| Welch Allyn, Inc. 4341 State Street Road Skaneateles Falls, NY 13153 USA | URGENT: Field Safety Notice | 2021-07-001-MKE-005 |

ELI280, MLBUR280 and BUR280 Electrocardiographs

ELI280 resting electrocardiograph - Patient mismatch/Software Upgrade

FSCA-identifier: 2021-07-001-MKE-005

Figure.1

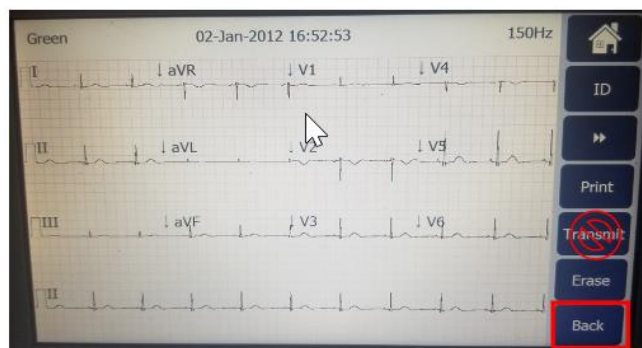
1. An ECG is acquired for Patient A and stored to the cardiograph.
2. An ECG is acquired for Patient B and stored to the cardiograph.
3. The ECG record associated with Patient A is retrieved from memory and any Patient Demographic information is edited.
4. After editing, the "Resting ECG" screen is presented as shown below. Figure 1
5. Pressing the TRANSMIT button from this screen (following any Patient Demographic edit) will transmit an ECG record other than for patient A. (see figure 2, which shows the Resting ECG screen).

If an ECG record is retrieved from the patient directory for a Patient Demographic edit to be performed, once the information has been edited and the screen above (Fig 1) is presented, do not press the transmit button. Instead, press the BACK button which will SAVE the changes to memory and present the user with the following screen, where the SYNC button can be used to transmit the desired record to the configured destination.

Figure.3

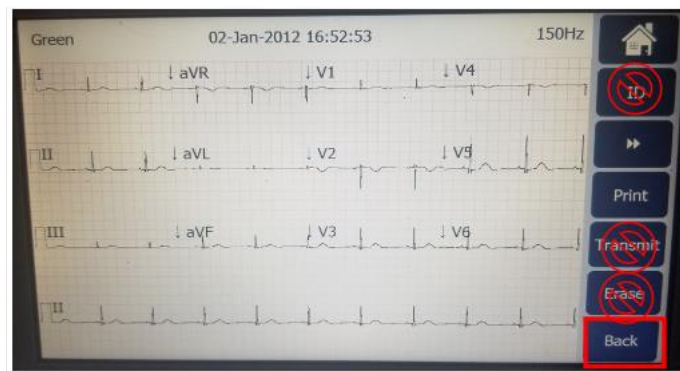
1. An ECG is acquired for Patient A and stored to the cardiograph.
2. An ECG is acquired for Patient B and stored to the cardiograph.
3. The ECG record associated with Patient A is retrieved from memory and ID information is edited.
4. After editing, the “Resting ECG” screen is presented as shown in Figure 3.
5. The user decides to make another ID Edit without leaving the “Resting ECG” screen and presses the “ID” button - Figure 3.

6. After the second edit is performed, the “Resting ECG” screen is once again presented as shown above.
7. Pressing the TRANSMIT button from this screen (following two ID edits in a row as defined above) will transmit an ECG record with the patient demographics

from Patient A and the ECG record for Patient B, this “hybrid” record is then stored in the cardiograph as second record with patient A demographics, and Patient B will no longer be listed in the directory.
